REGULAR MEETING OF THE THIRD LAGUNA HILLS MUTUAL ARCHITECTURAL CONTROL AND STANDARDS COMMITTEE

Monday, April 22, 2019 – 9:30 a.m. Laguna Woods Village Community Center Board Room 24351 El Toro Road

SUBJECT: Variance Request

Ms. Julie A Neilson of 3213-D (La Reina, PL704RB, P43B) Room Extension onto Previously Extended Common Area

SITE PLAN SCALE: 1/8"=1'-0"

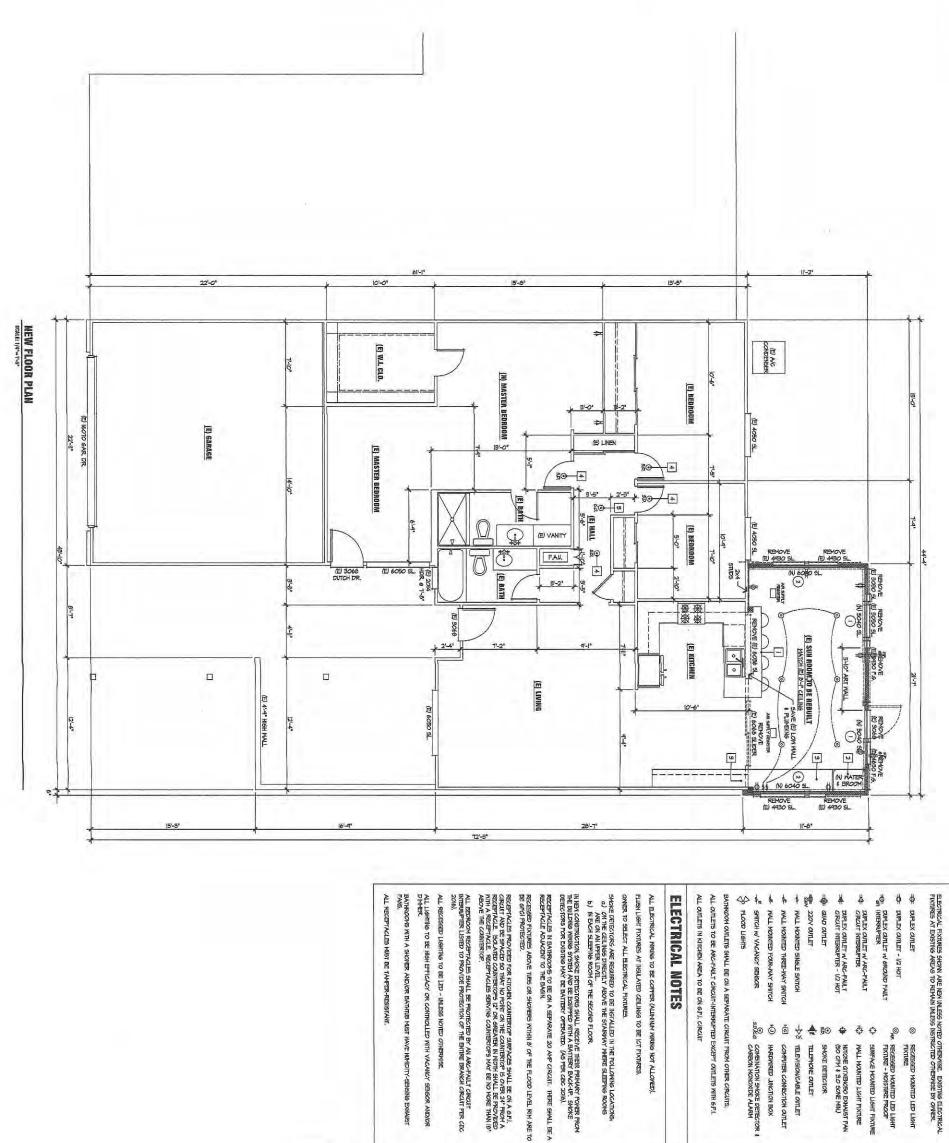
Ms. Neilson proposes to remove the existing slump stone block wall with windows and patio cover, and replace it with a wood frame and stucco construction room extension.

The extension will have a gabled roof, tied in below the existing building roofline at 12'8", using tiles to match the existing roof for aesthetic consistency. The rear elevation will have two 5' wide by 4' tall windows, while each side elevation will have a 6' wide by 4' tall window. Header heights will remain consistent with the rest of the unit's existing windows.

Approximately 139 square feet of the proposed room extension will fall over previously extended patio area (Appendix B).

Staff recommends the Board deny the request to construct a room extension on previously extended Common Area patio. Should the Board approve the request, Staff recommend it be with the conditions in Appendix A.

Staff recommends denial of this request in conjunction with current Third Mutual's Common Area Use Policy (RESOLUTION 03-18-146) "BE IT RESOLVED FURTHER, that no further alteration may be approved or constructed on any previously approved or "grandfathered" alteration that encroaches upon common area, other than like for like, that augments, enlarges, or changes the construction, purpose, or use of the previously approved or grandfathered alteration."

NEW FLOOR PLAN

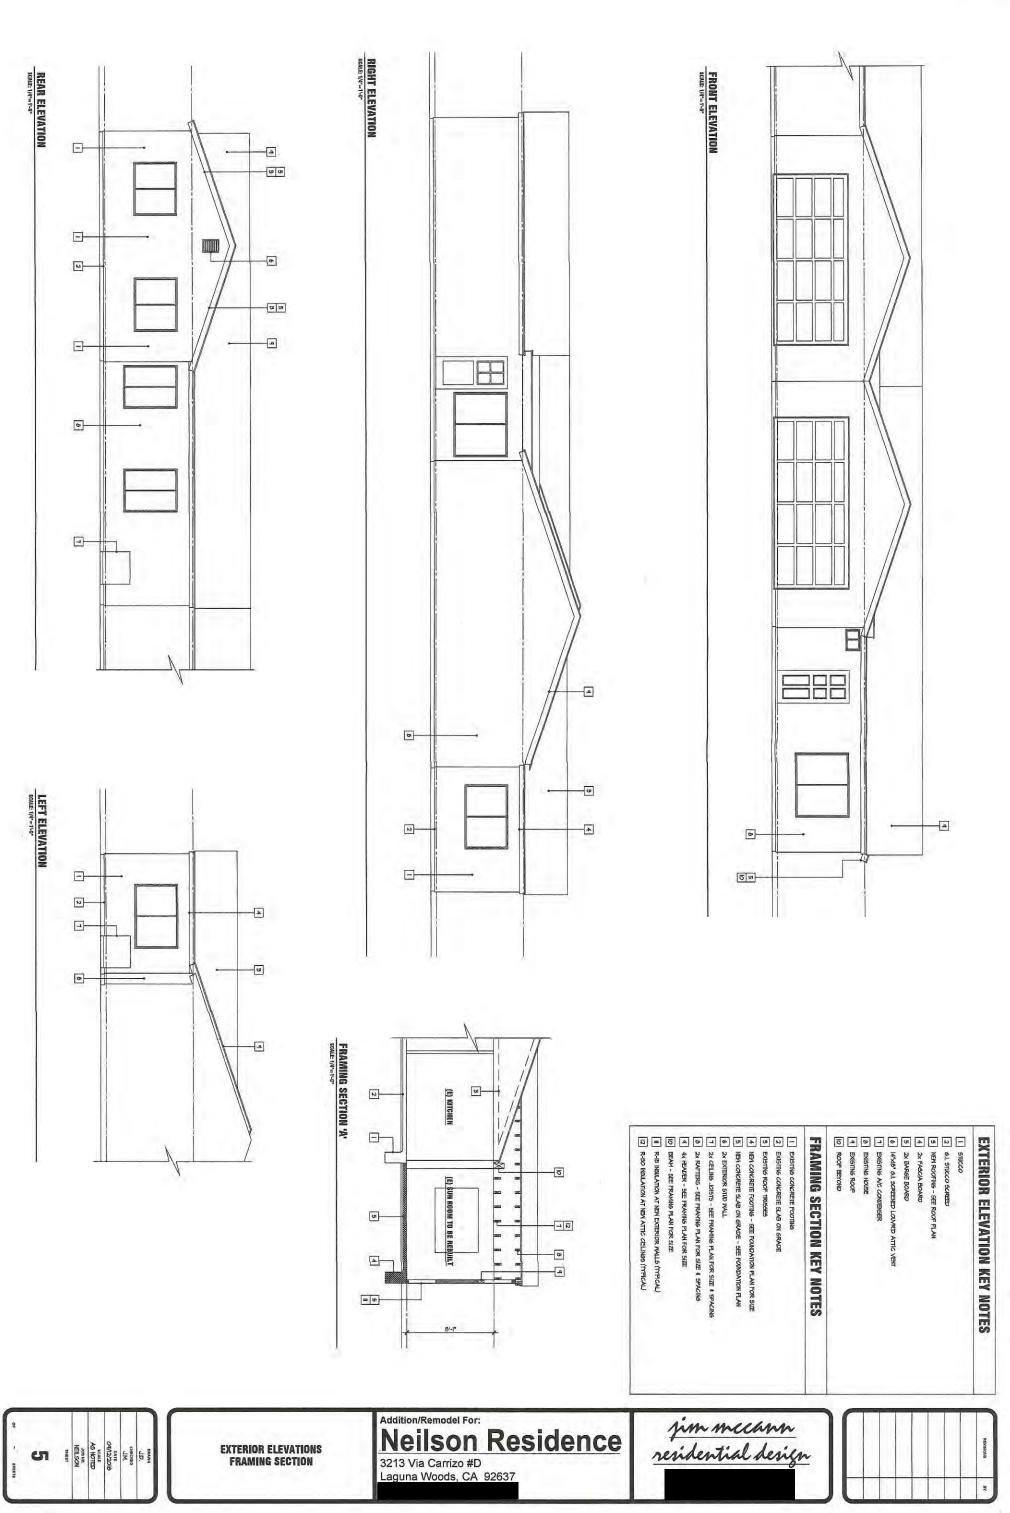
The existing sliding glass door and window from the dining room and kitchen to the new proposed room extension would be removed to extend the new habitable area.

CORDOBA #7 NEW ARRANGEMENT DIMENSION ARE APPROX. NEED TO FIELD VERFY WALL THICKNESS ARE NOT SHOWN W/FULLY EXTENDED AND WALKIN CLOSET DOUBLE DOOR (DO NOT SCALE)

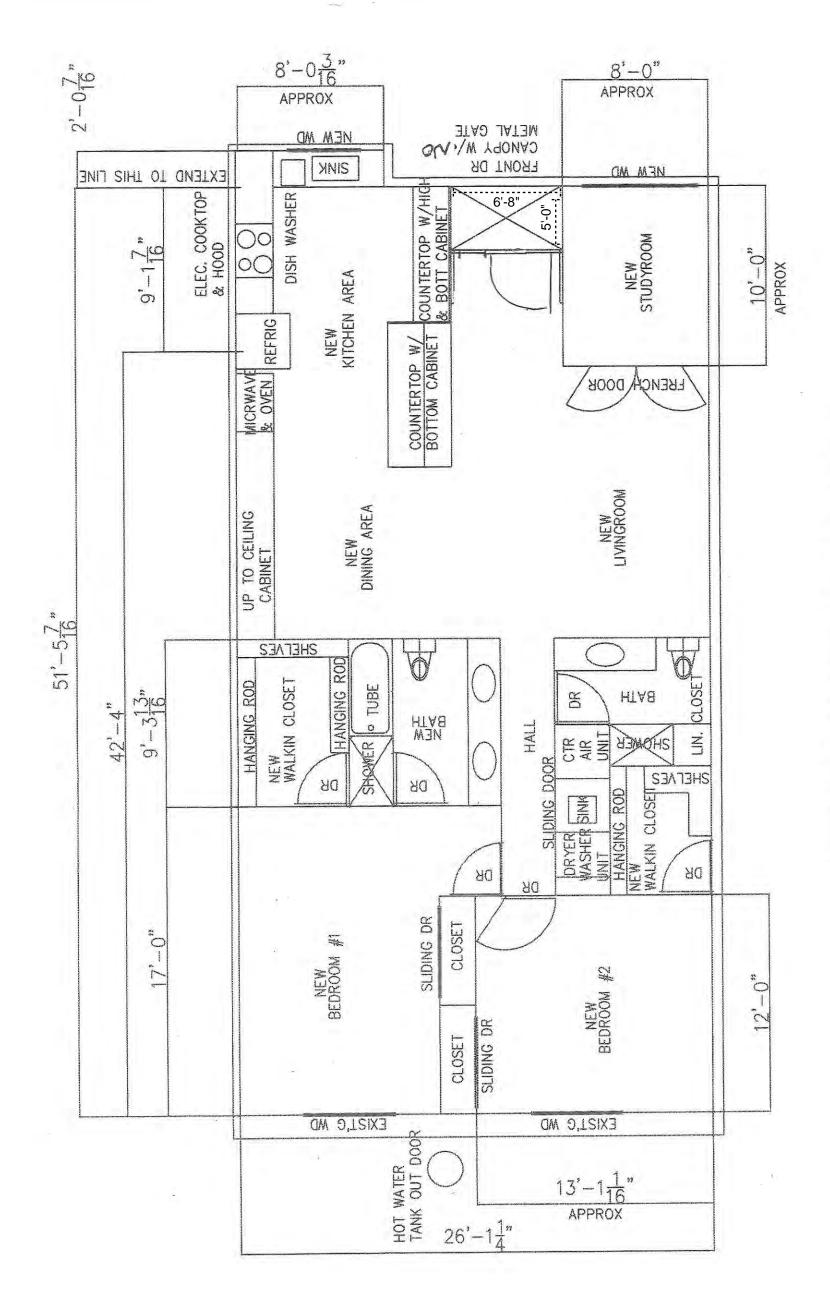
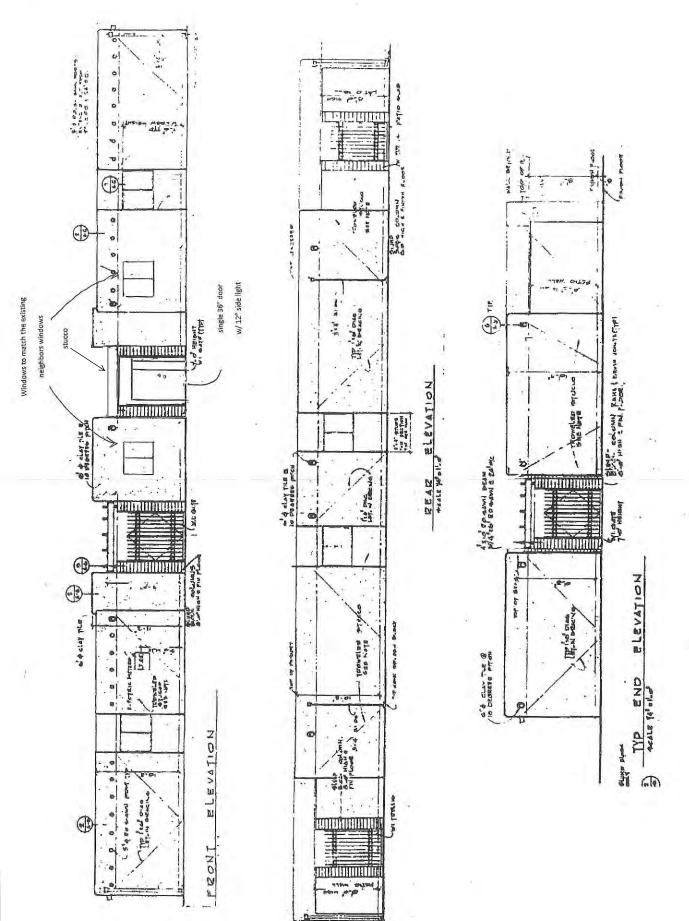
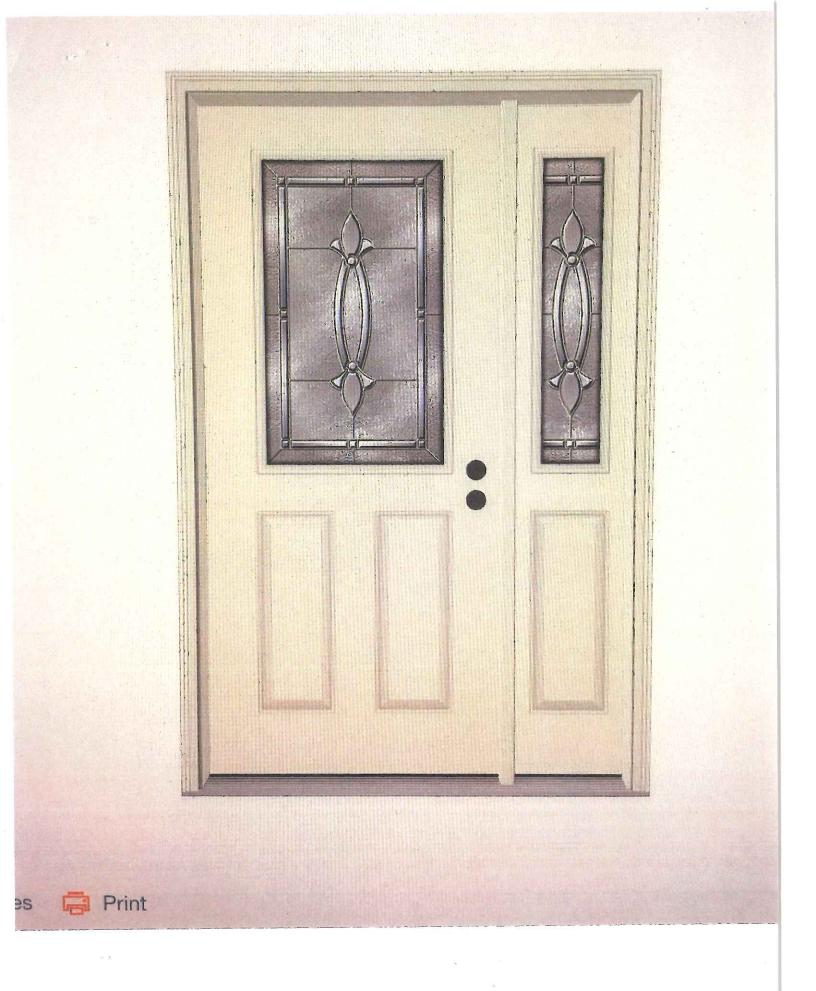
Mr. Keng is proposing to enclose the front patio of the unit by installing a new roof over the existing front patio, removing the existing entry gate and replacing it with a wood frame and stucco wall with a single entry door with side lite.

The proposed entry door will be recessed 5' from the front wall of the unit to provide a covered entrance. The new entry landing will be the width of the existing entryway (6'8" wide, column to column). The front of the unit will have a stucco finish up to the height of the existing trellis (approx. 9'3") to maintain the continuity of the building's fascia.

Windows will be installed on each side of the entry door on the front elevation of the unit. Both windows will measure 4' wide by 4' tall with a header height to match the existing windows on the same side of the building.

Mr. Keng is also proposing to relocate Bathroom 1 to the existing enclosed atrium. This would be achieved by installing a wall in the atrium to separate a new walk-in closet with the proposed bathroom. The new bathroom would contain a bathtub, shower, toilet, and a double vanity. A walk-in closet and a laundry area would replace the existing Bathroom 1 space. Detailed plumbing plans, along with a VMS Staff line inspection, will be required prior to a Mutual Consent being issued (See Appendix A).

Staff recommends the Board approve the request to construct a room extension over the original patio slab on Exclusive Use Common Area and relocate a bathroom to the existing enclosed atrium with the conditions in Appendix A.

Staff recommends approval of this request due to finding no impairment of the structural integrity, mechanical systems, or drainage of the surrounding units or lessening of structural support
